# **Technical Service Information**

### THM 440-T4 NEW 2 PLATE 4TH CLUTCH

Figure 1

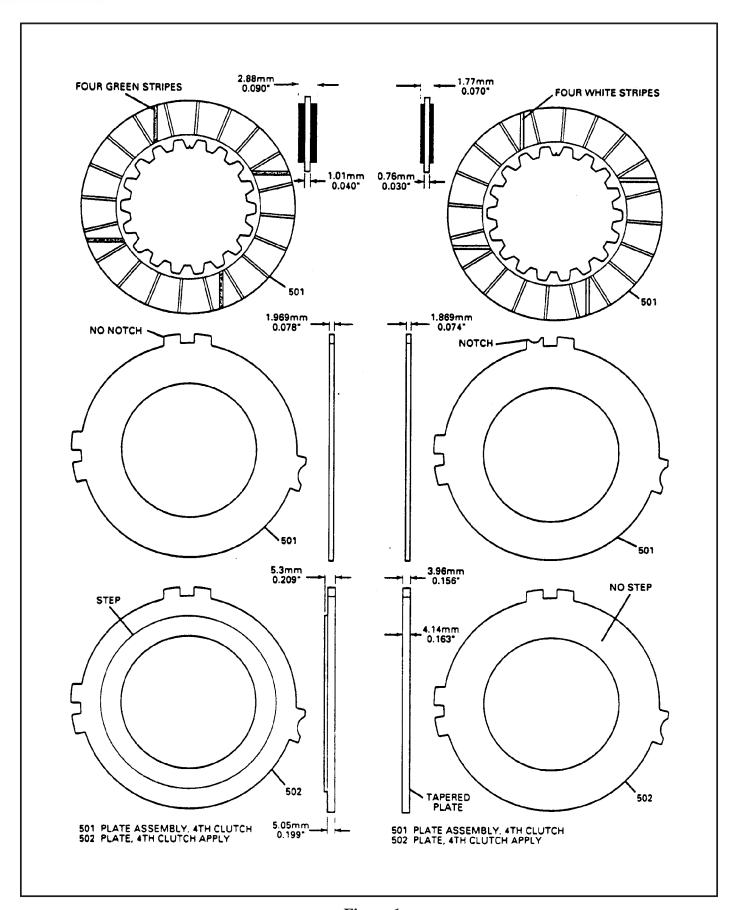
**CHANGE:** A new "Two Plate" 4th clutch assembly was used to replace the Single Plate 4th clutch

assembly for SOME MODELS ONLY on the 1990 THM 440-T4 transaxles (See Figure I).

- (1) 4TH CLUTCH LINED PLATES Were made thinner by ,020" than the previous lined plate, and can be identified by the four WHITE stripes, while the single plate lined plate has four GREEN stripes (See Figure 1). The Single Plate 4th Clutch is .090" thick, and the new "Two Plate" 4th Clutch plates are ,070" thick.
- (2) 4TH CLUTCH STEEL PLATES Were made thinner by ,004" than the previous plates, and can be identified by a "Notch" cut into one of the tabs (See Figure 1). The single plate 4th clutch steels are ,078" thick, and the new "Two Plate" steels are ,074" thick.
- (3) 4TH CLUTCH APPLY PLATE Was machined thinner than the previous apply plate, and the step was removed. Refer to Figure 1.

Will not interchange without calibration changes. May create harsh shifts if the Two Plate type is installed where the Single type was, or soft shift if the Single type is installed where the Two Plate type belongs.
